R66 SERVICE BULLETIN SB-19

SUBJECT: Revised Instrument Markings

ROTORCRAFT AFFECTED: R66 Helicopters S/N 0003 thru 0752.

FIGURE 1

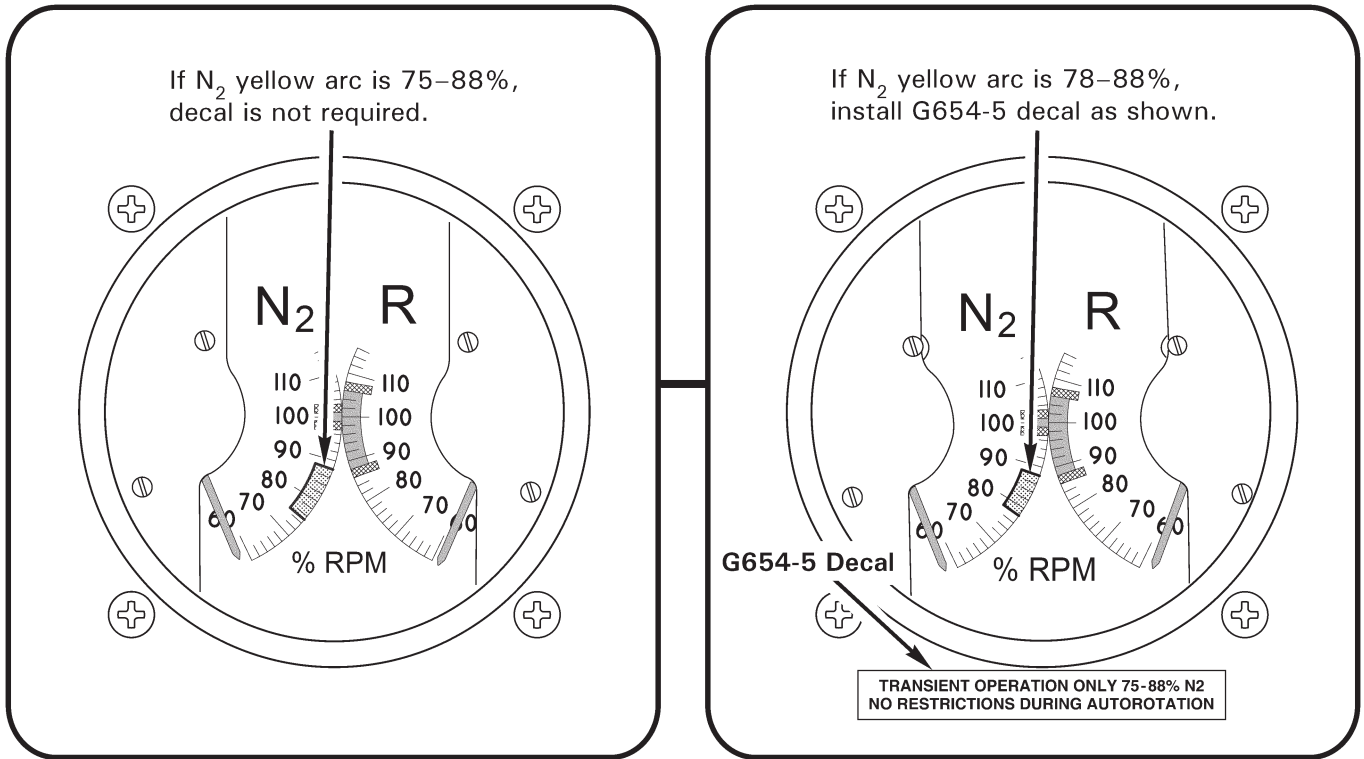
1. Refer to Figure 1. If installed engine tachometer (N_2) yellow arc is 78–88%, install G654-5 decal as shown. If N_2 yellow arc is 75–88%, decal is not required.
2. Refer to Figure 2. If installed airspeed indicator green arc is 0–140 knots (0–130 knots for some models) install G654-6 decal as shown. If indicator has a yellow arc above 110 knots, decal is not required.
3. If electronic flight display is installed, have applicable authorized Aspen (www.aspenavionics.com) or Garmin (www.garmin.com) facility revise airspeed indication to match 19 October 2016 POH revision.
